Addendum No. 1
February 9, 2023

Project: Harrisburg Elementary School #8
Harrisburg, South Dakota
Architecture Incorporated Project #3000

Architect: Architecture Incorporated

HARRISBURG ELEMENTARY SCHOOL #8
FLOOR PLAN - AREA A

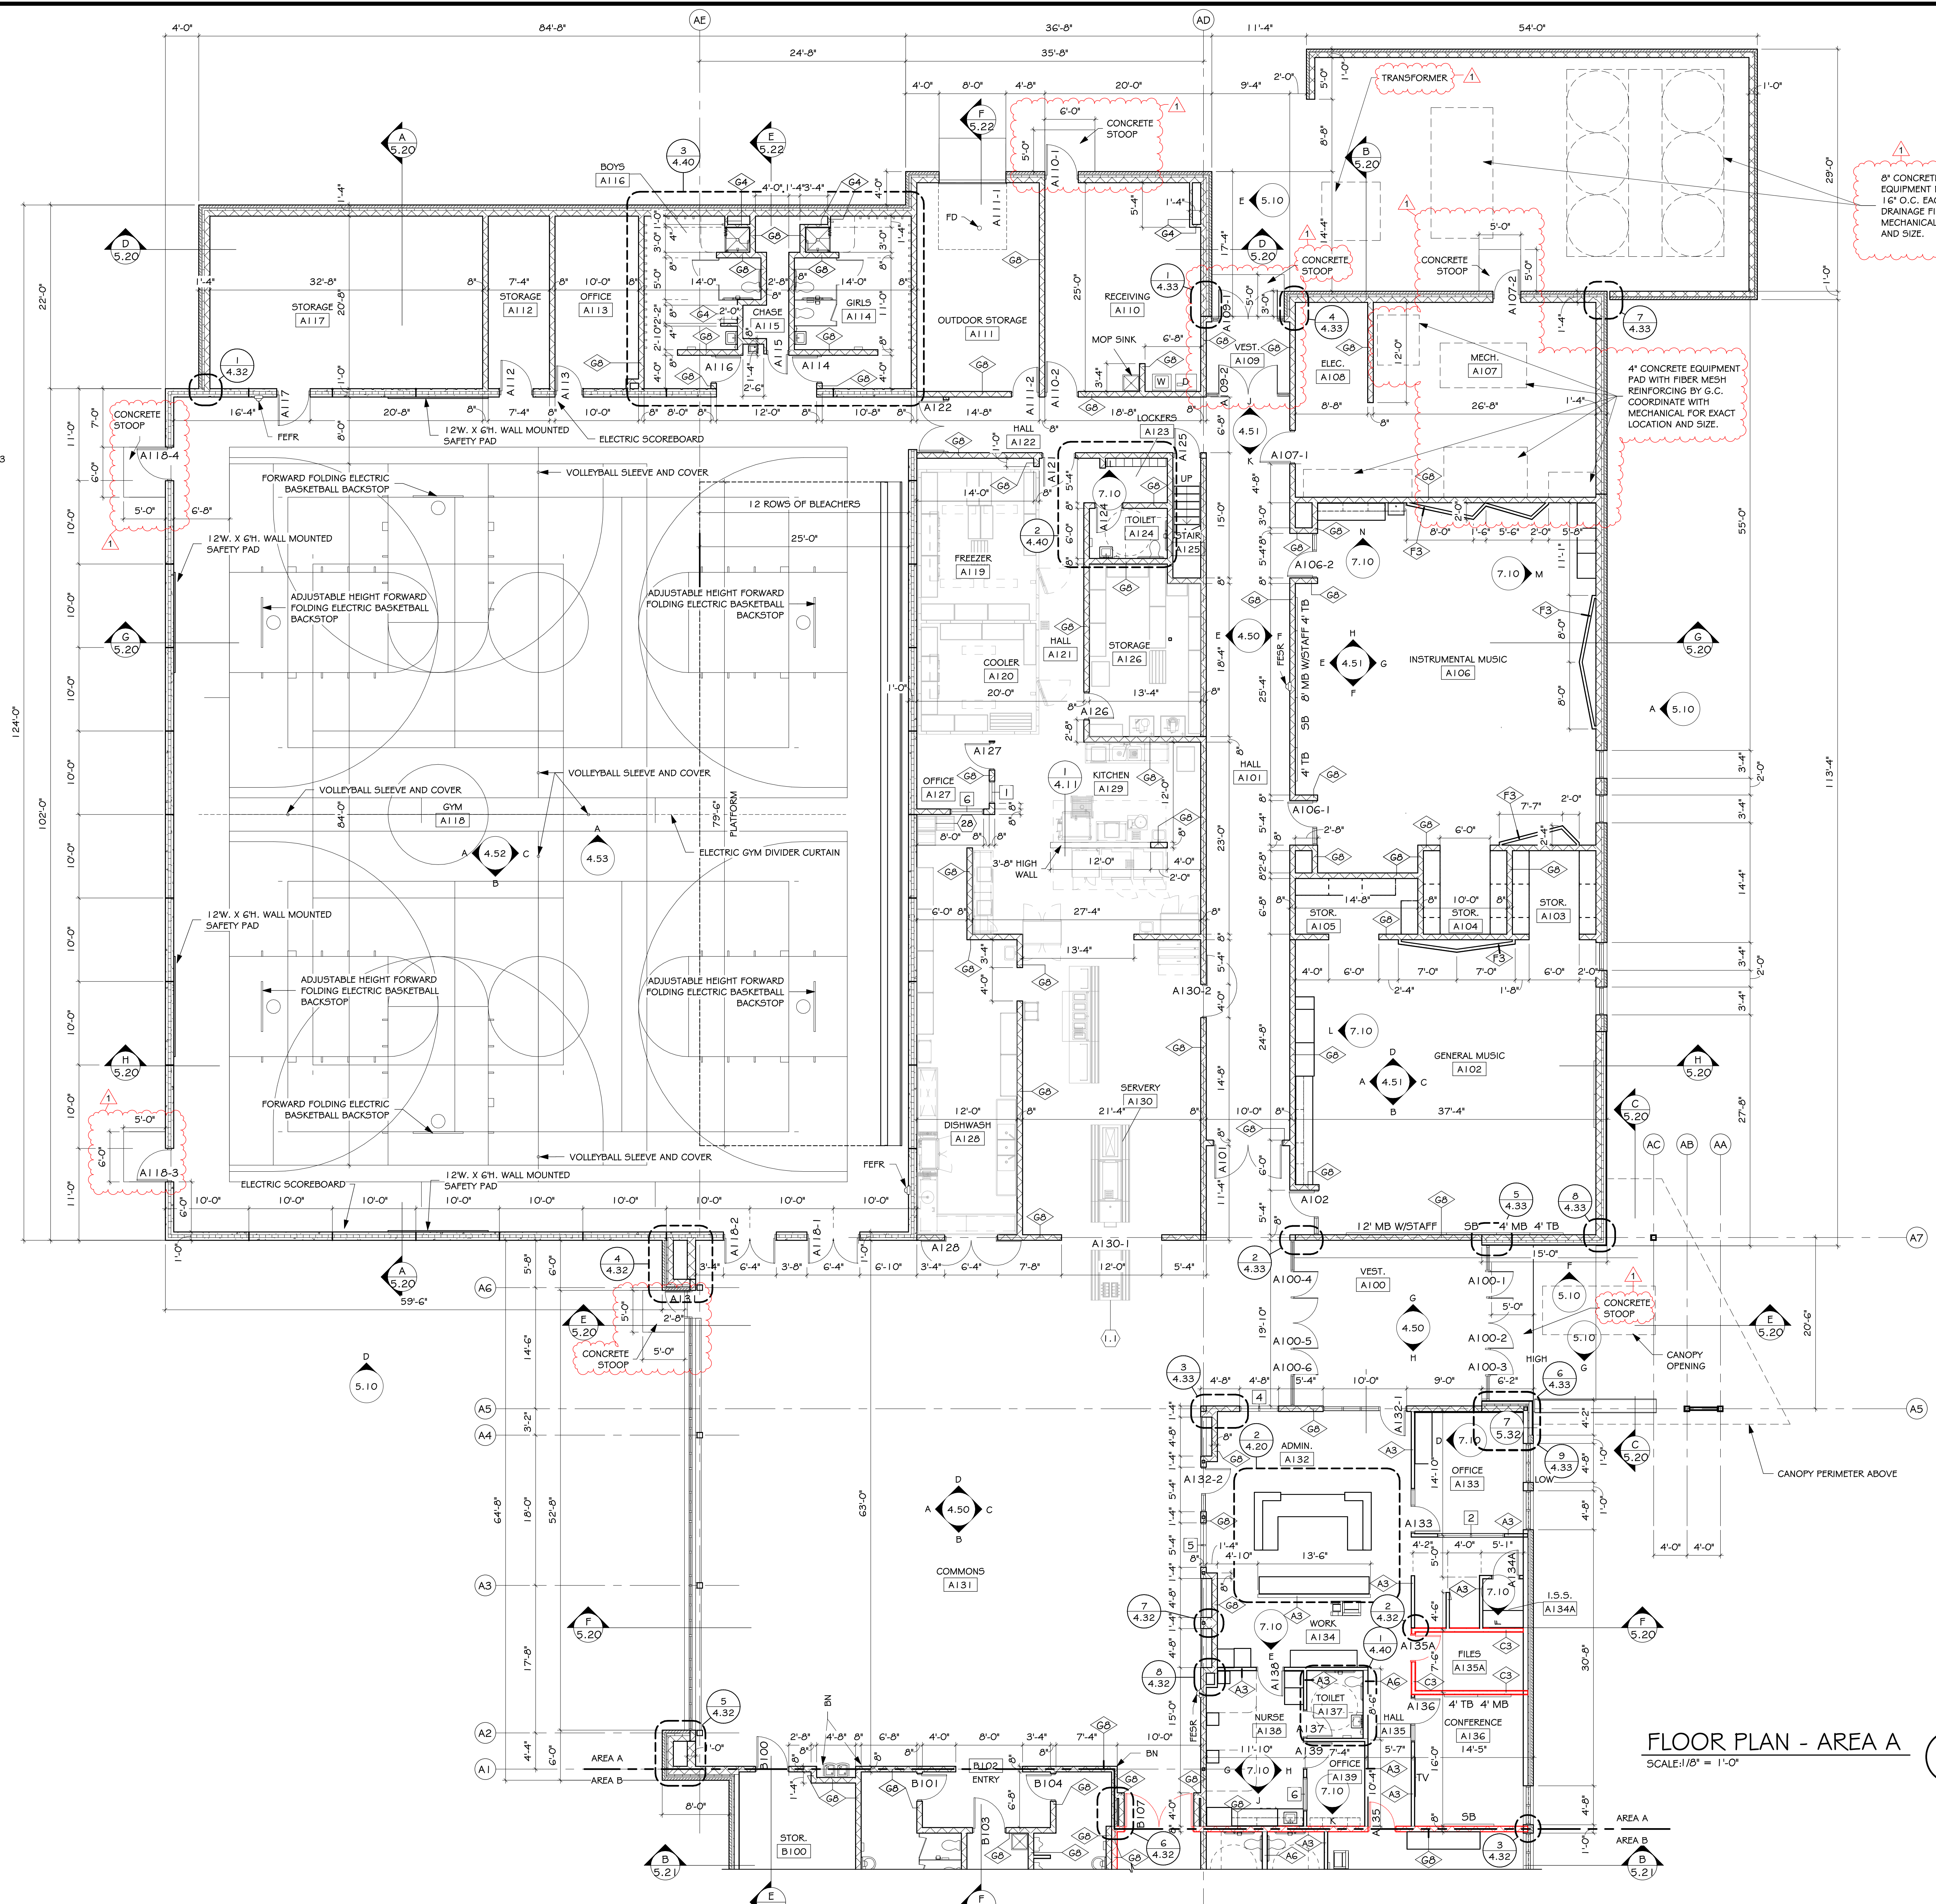
- a) Install concrete stoop with frost-free footing at all exterior doors. Reference *revised* drawing Sheet 4.11, revision dated 2-9-23, attached to the end of this addendum for location and size of the concrete stoops.

- b) Add plan note for concrete equipment pads for the outdoor chiller, ice storage tanks and other mechanical equipment as indicated per *revised* drawing Sheet 4.11, revision dated 2-9-23, attached to the end of this addendum.
 - i) See clouded plan note for concrete pad thickness and reinforcing size/spacing.
- c) Relocate aluminum entrances A109-1 and A109-2 as indicated per *revised* drawing Sheet 4.11, revision dated 2-9-23, attached to the end of this addendum; shift aluminum entrances to the south as shown.

8" CONCRETE OUTDOOR EQUIPMENT PAD WITH #4 BARS @ 16" O.C. EACH WAY, OVER 2" DRAINAGE FILL. COORDINATE WITH MECHANICAL FOR EXACT LOCATION AND SIZE.

4" CONCRETE EQUIPMENT PAD WITH FIBER MESH REINFORCING BY G.C. COORDINATE WITH MECHANICAL FOR EXACT LOCATION AND SIZE.

MEZZANINE PLAN - AREA A

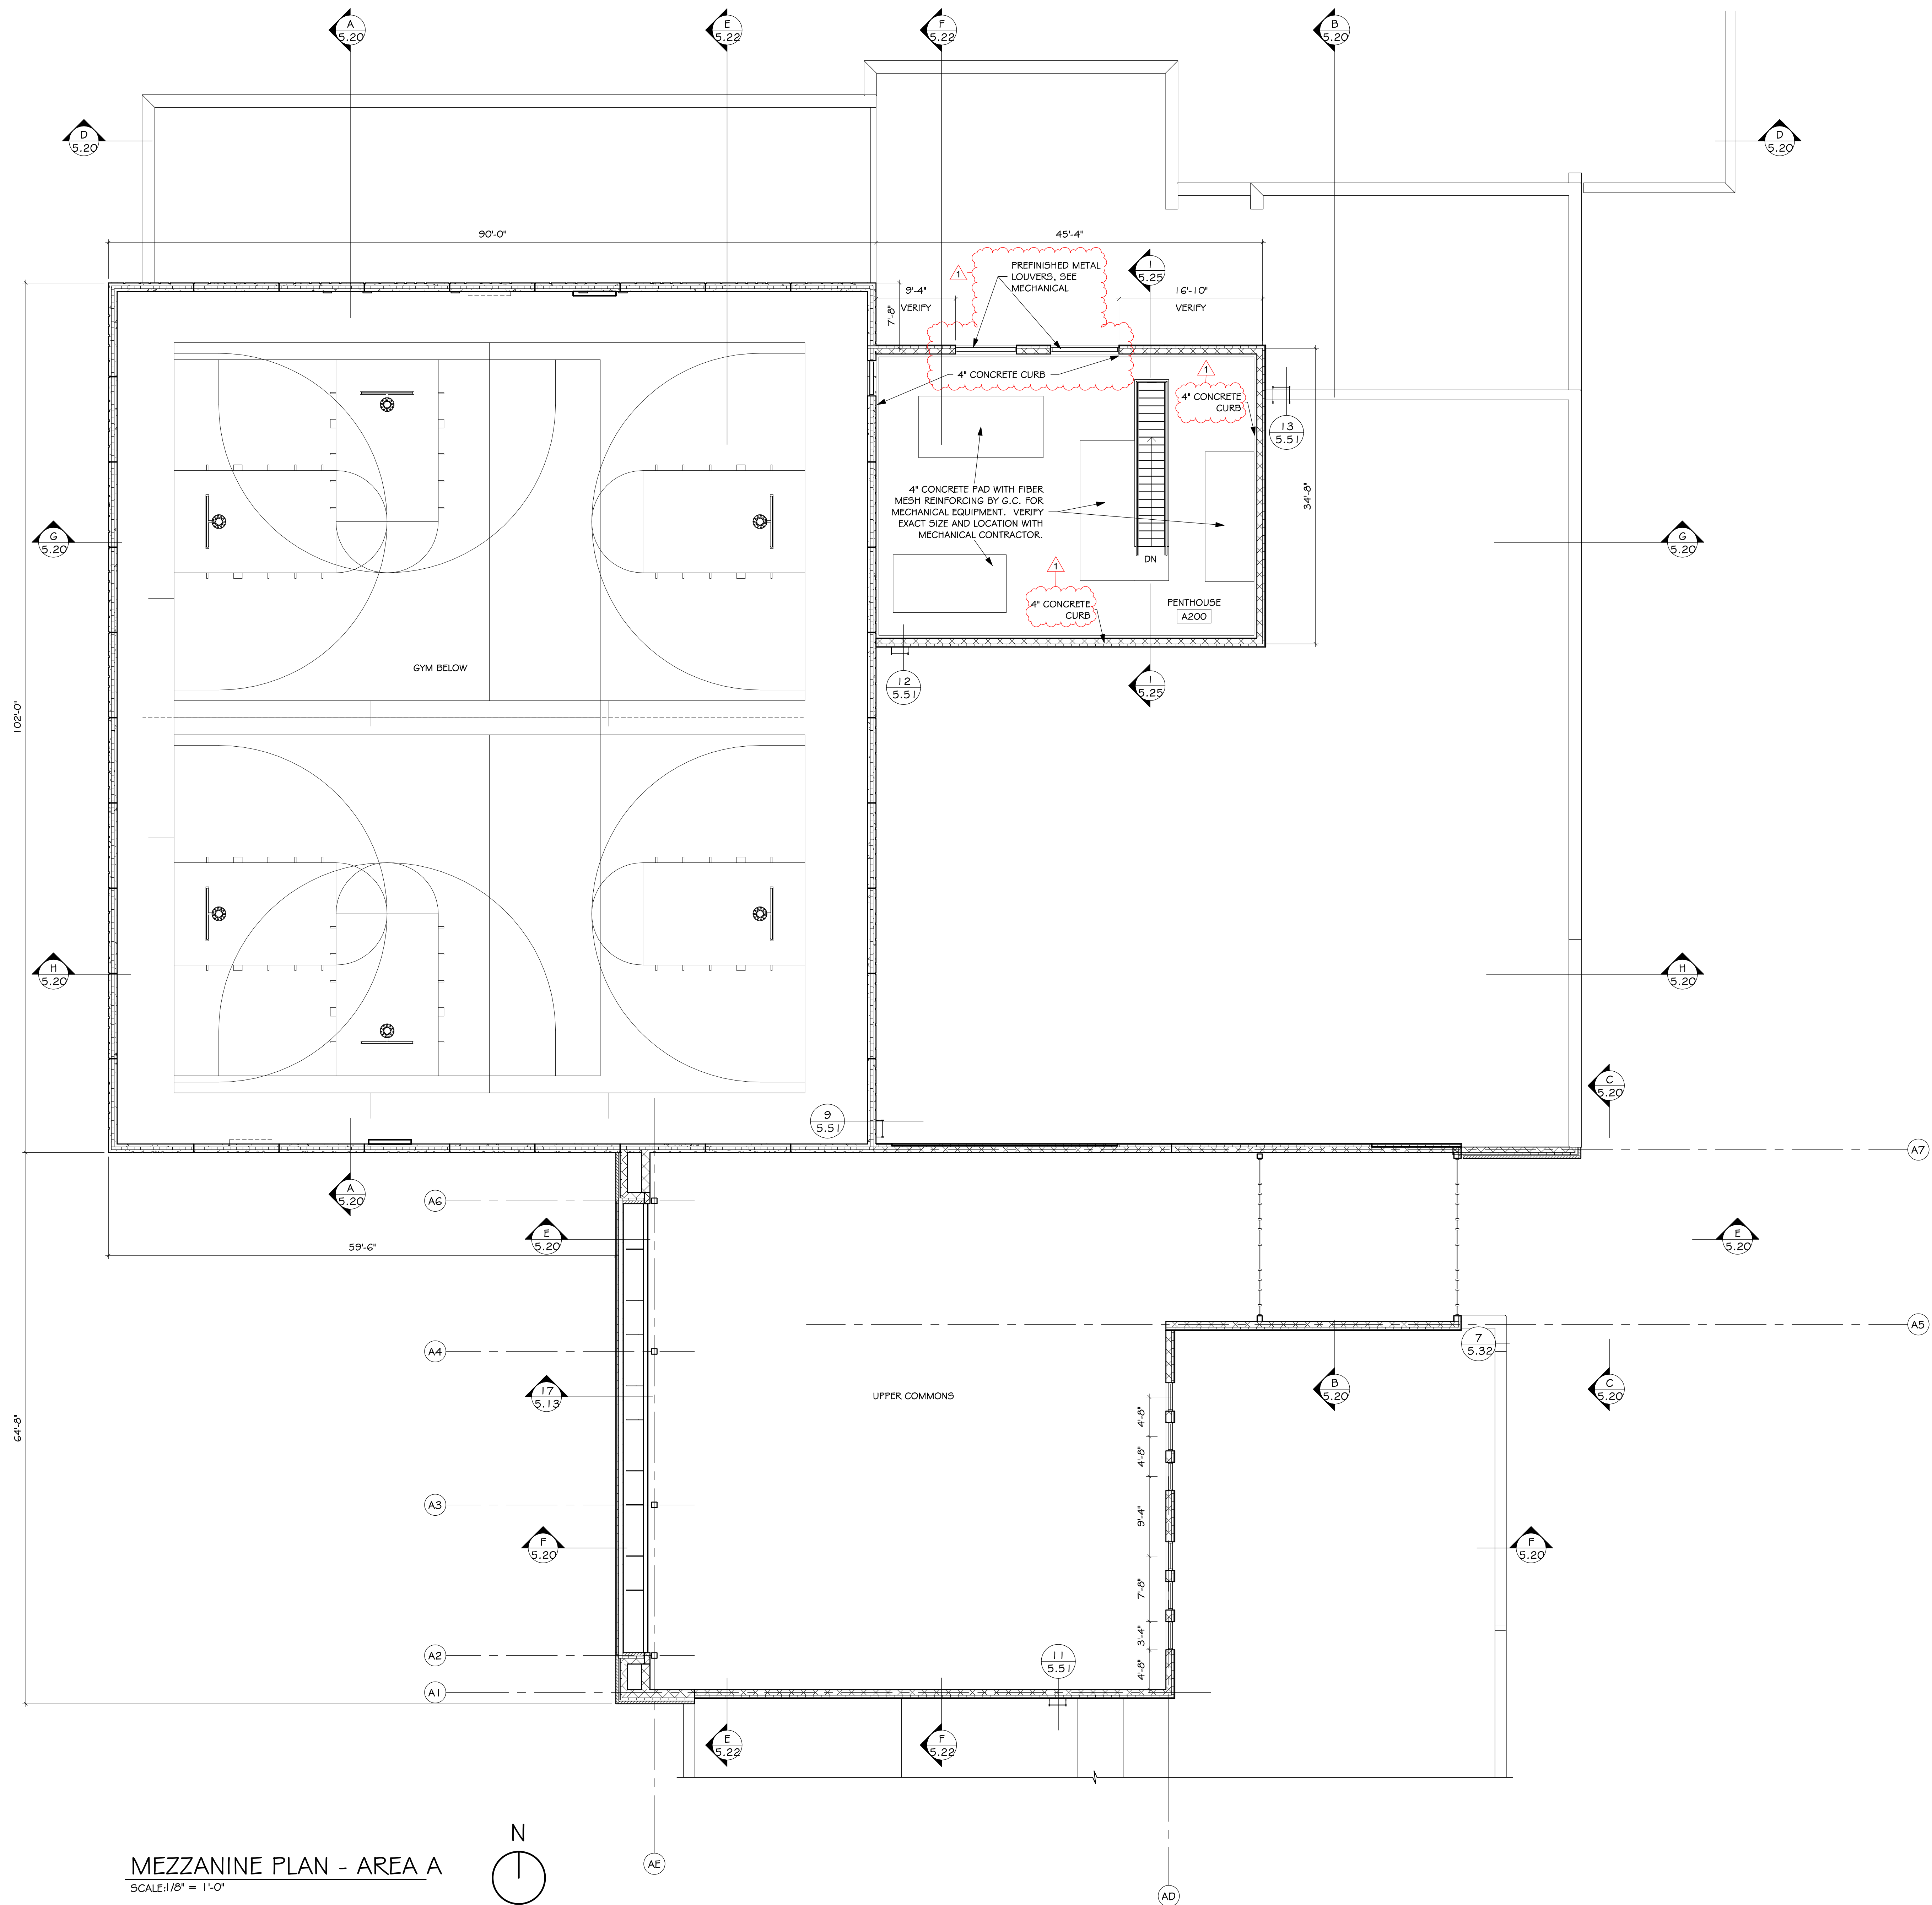
- a) Install 4" high perimeter concrete curb at A200 PENTHOUSE as indicated in the *revised* drawing Sheet 4.14, dated 2-9-23 attached to the end of this addendum.
- b) Provide and install two (2) prefinished metal louvers on the north wall of A200 PENTHOUSE as indicated in the *revised* drawing Sheet 4.14, dated 2-9-23 attached to the end of this addendum; coordinate with mechanical for exact location and size of the louvers.
- c) Disregard cross hatch pattern originally shown on the roof adjacent to south wall of A200 PENTHOUSE.
